DeKalb County Historic Preservation Commission

Staff Report

A. 467 Burlington Road, James Johnson. Install pervious paver system with turf and gravel and a pervious brick and stone step walkway in backyard. **1247942**.

Project Description
*467 Burlington Road
Driveway and Walk
Improvements*
EMORY UNIVERSITY
DEKalB COUNTY, GEORGIA

1 Site Plan
L1 1" = 10'-0"

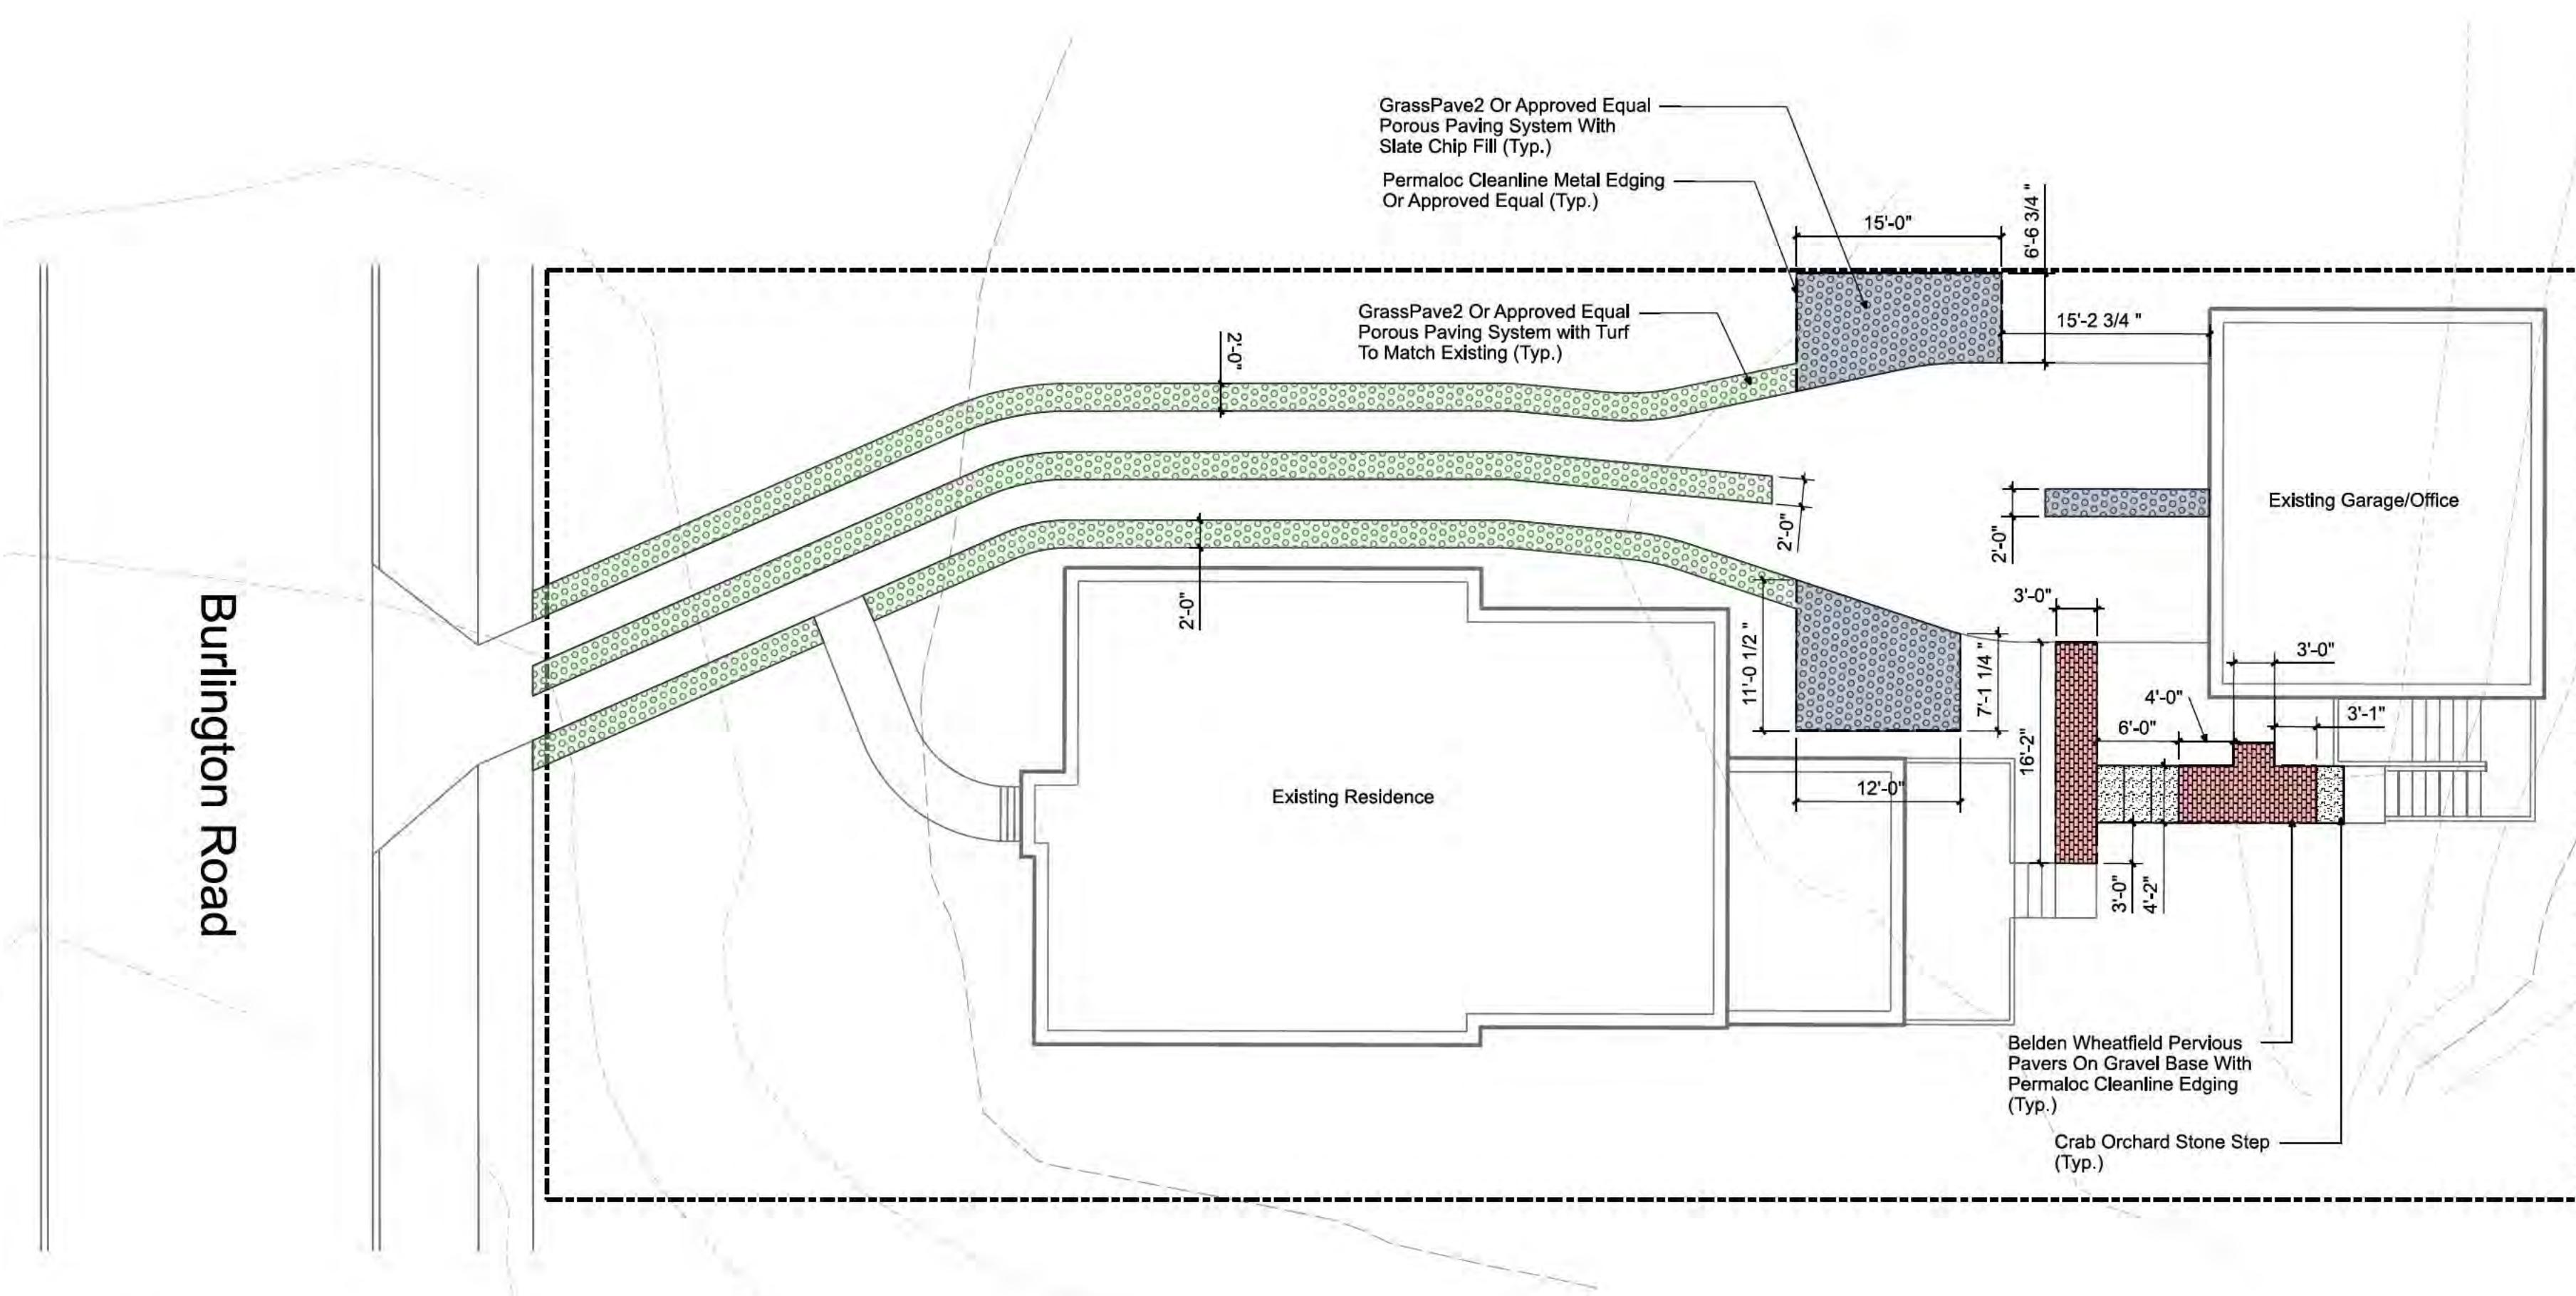
The applicant proposes installing pervious pavers on a nonhistoric property. Pervious grass pavers and turf will be installed on either side and in the center of the existing ribbon driveway; this will include the installation of stone chips on either side of the rear portion of the driveway, in the backyard of the property, to allow for cars to back up in the backyard as well. The installation of the pervious grass pavers, turf, and stone chips will replace the existing turf and excavating materials along the side and center of the driveway, and the pea gravel and metal edging on either side of the rear portion of the driveway. Pervious brick pavers with stone steps will be installed to create a walkway in the backyard, connecting the rear of the nonhistoric house to the nonhistoric garage located on the rear of the property.

Approve. The proposed changes do not appear to have a substantial adverse effect on the property or the district. This application appears to meet the guidelines and the staff recommends approval.
